Site: Paradise View Universal Apartments

Re: Drainage Ordinance (14-5-2-1) Violations for Erosion and Sediment Control and Construction Site Waste(s)

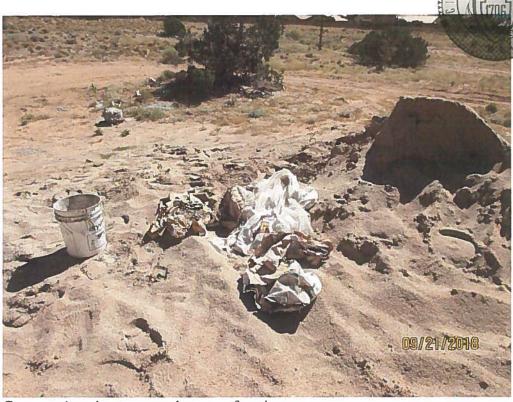
Wash-out on lot east of project.

- 1. Remove all instances of wash-out on the site and on the lot to the east, west and south.
- 2. After cleaning up the lot to the west, stabilize the disturbed area.
- 3. Remove wash-out, construction site waste and trash on lot east, south and west of project.
- 4. Remove the dirt ramp and dirt from the street. Do not build another dirt ramp.
- 5. Remove sediment and construction site waste from the gutter. Along the frontage of the property to approximately 40 feet east of the property line.
